15 Response to Comments from Businesses/ Organizations

Bay Area to Central Valley Supplemental EIR/EIS - RECORD #3 DETAIL

Re: Comments to Partially Revised Draft Program EIR/EIS (Bay Area to Central Valley High-Speed Train); Opposition to A2-UPRR / Avenue 24 (Henry Miller) alignment(s); and Preferred Alternatives and Suggestions

Enclosures:
Figure 1. Area Map - California High-Speed Rail Project - Bay Area to Central Valley Segment

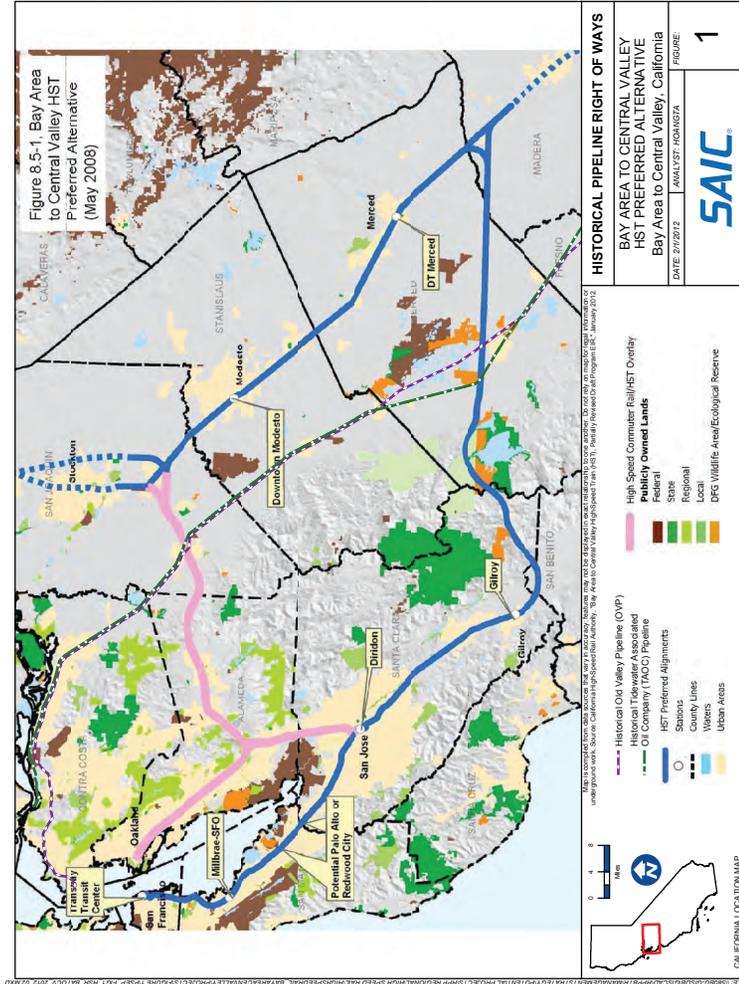
Portions of the former Old Valley Pipeline (OVP) and Tidewater Associated Oil Company (TAOC) pipelines existed within the Central Valley footprint of the proposed California HSR: Bay Area to Central Valley Segment (Figure 1). The historic pipelines were constructed in the early 1900s and carried crude oil from the southern San Joaquin Valley to the Bay Area. Pipeline operations for the OVP ceased in the 1940s, and in the 1970s for the TAOC pipelines.

Figure 1 illustrates the location of the former OVP and TAOC ROWs within the proposed footprint of the California HSR project in Merced County, as shown in the DEIR. CEMC understands that there are several construction options being evaluated as part of the DEIR. To facilitate incorporation of the information contained in this letter into project planning and engineering documents, CEMC can provide Geographic Information System pipeline location files to project planners on request.

CEMC recommends that the California HSR Authority be prepared to potentially address residual weathered crude oil, pipelines, and ACM from the former OVP and/or TAOC systems during subsurface construction activities conducted in proximity to the former pipeline ROWs. This potentiality is easily managed with some advanced planning. CEMC would appreciate being informed of any encountered petroleum, pipeline, and pipeline-related ACM in the vicinity of the former OVP and/or TAOC ROWs.

Comment acknowledged. Chapter 3.10 of the 2008 Final Program EIR assessed public utility conflicts at a broad scale, with a focus on major conflicts such as electrical transmission lines, electrical substations or power stations, natural gas pipelines, and wastewater treatment facilities as representative of utility impacts. Utilities conflicts are considered significant, and mitigation strategies were identified. Furthermore, Section 3.11.6 explains that potential hazardous materials/waste sites, which would include an analysis of potential impacts related to the former Old Valley Pipeline and Tidewater Associated Oil Company pipelines along with other known and unknown potential hazards that may be encountered during construction, will be included in second-tier project-level environmental documents. Also refer to Standard Response 3 regarding level of detail.

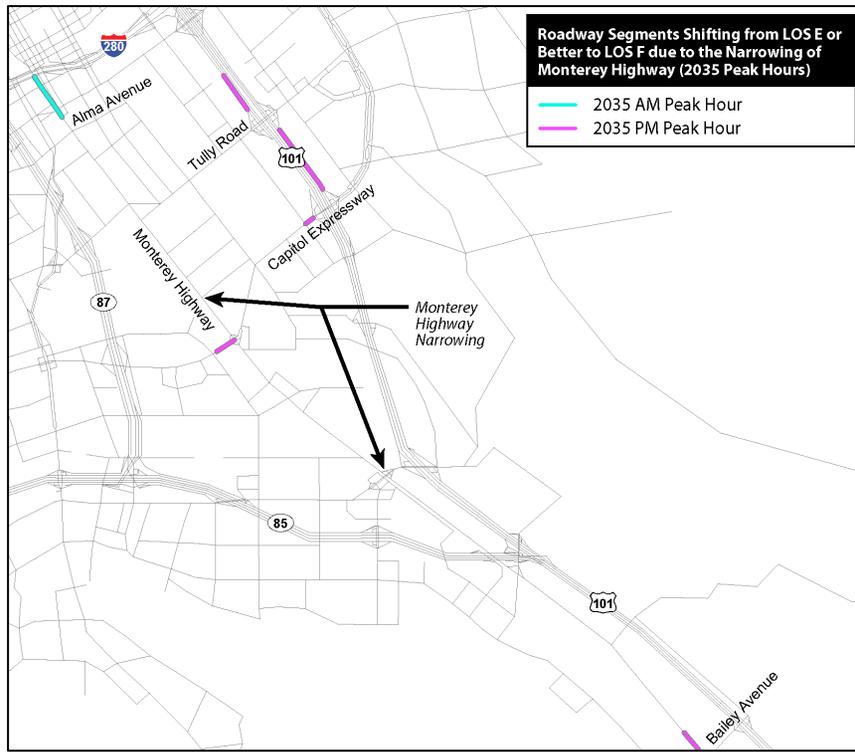
As a result of Commenters' litigation, a map is offered showing the locations of lane reductions and right-of-way shifting on Monterey Highway. (Figure 2-2.) Its absence in the 2010 Revised Final Program EIR/EIS (RFPEIR) was one of the reasons that document failed as a full disclosure document for the project. This map is still inadequate, however, as it does not depict the location of the UPRR tracks or provide arrows indicating the direction of the shift.

The litigation also resulted in the disclosure of detailed traffic congestion maps (Figures 3-2 through 3-5.) They indicate that narrowing Monterey Highway will make a highly congested region even more congested. However, by limiting the metric to the unnecessarily broad "LOS E or worse," the maps and analysis fail to address what is perhaps the most important question to the public: will the road network descend into gridlock, experiencing LOS F as a result of the roadway narrowing? The text hints at the answer, but fails to be definitive: "If the peak hour of travel demand is fully occupied, then travelers then shift their time of travel to shoulder hours as a function of time and space." (p. 3-16.) The public needs to know if this project will create more LOS F, which would increase travel times, and make traveling at peak hour even more onerous.

The text of Chapter 2 of the Partially Revised Final Program EIR accompanying Figure 2-2 depicting the locations of Monterey Highway narrowing and right-of-way shifting explains that where the lanes and right-of-way will shift, it will shift to the east. Please refer to page 2-6 of the Partially Revised Final Program EIR.

A full picture of the actual volume shifts in the traffic network is contained within the figures provided in the appendix to the Traffic and Circulation Technical Memorandum: Monterey Highway.

In response to the comment's focus on LOS F, the following analysis is provided. Under the 2010 peak hours, the narrowing of Monterey Highway would not cause any of the roadway segments to deteriorate from LOS E or better to LOS F. During the 2035 AM peak hour the narrowing would cause one segment of SR 82 near I-280 to deteriorate to LOS F. During the 2035 PM peak hour, the narrowing will lead to the deterioration of one roadway segment each on Monterey Highway, US 101 and I-280 to deteriorate to LOS F. These roadway segments are shown in the figure below. However, it should be noted that this analysis does not include the traffic diverted from the local street system to the HST, which could negate the impact of additional traffic. This level of analysis will be conducted at the second-tier project-level and will be documented in the project-level environmental document and traffic report. The location of the UPRR tracks will be noted in the figures presented for the project-level analysis.
